NOISE AND VIBRATION IMPACT ASSESSMENT ADDENDUM

5 Kingdom Street

Noise and Vibration Impact Assessment Addendum

Figure 1 Rooftop plant proposals highlighted on the proposed level 19M plan

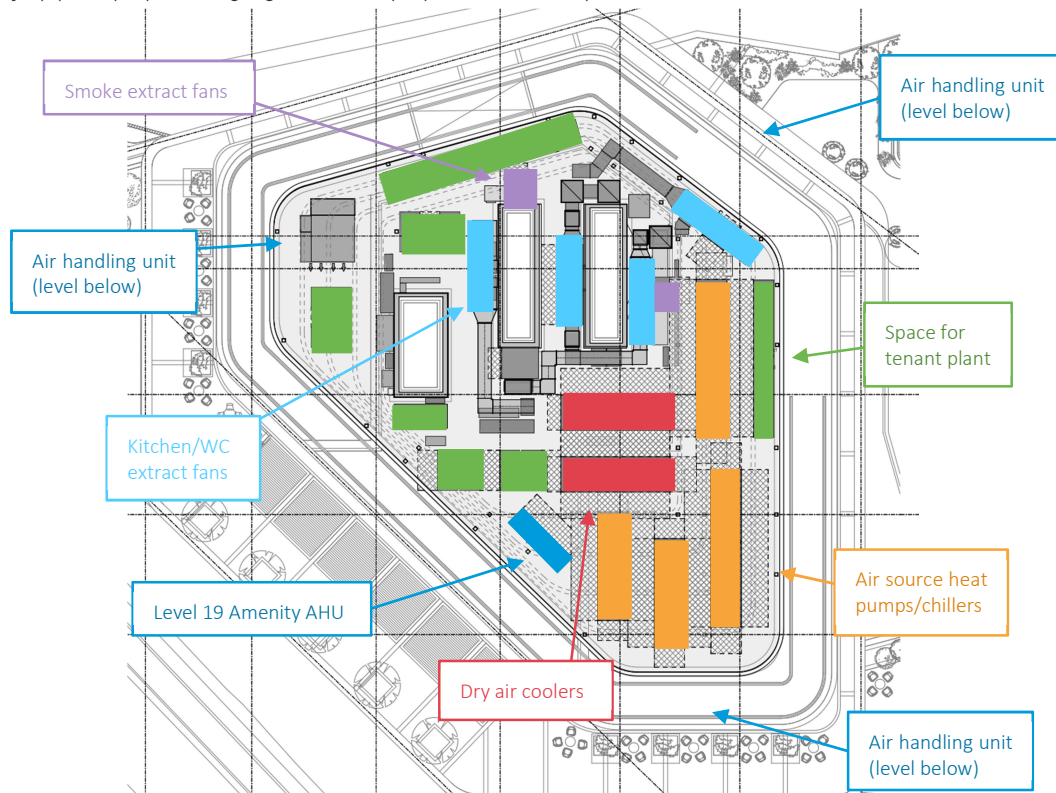
Among the changes in the new scheme is alteration to the external rooftop plant proposals. These changes have been assessed by recalculating noise emission to the neighbouring properties. The other changes to the design are not expected to have a material effect on the outcomes presented in the original noise and vibration impact assessment, and so those outcomes are considered to remain valid.

The new rooftop plant layout covers two floors at level 19 of the proposed building; this is shown in Figure 1:

With the assumptions made in this assessment, it is expected that the *specific sound level* at the nearest receivers north and south of the site will be at or below 49 dB L_{pA} during office hours. This is around 1 dB quieter than was predicted in the previous assessment.

Noise from the updated normal-use plant proposals has been assessed, and predicted to be around 1 dB quieter at the neighbouring properties. This is still at least 10 dB below the *background sound level* that was established in the previous assessment during expected office hours. As with the previous assessment, it is expected that the noise levels from the proposed plant will considerably reduce outside of office hours, enabling the requirement to be met overnight as well.
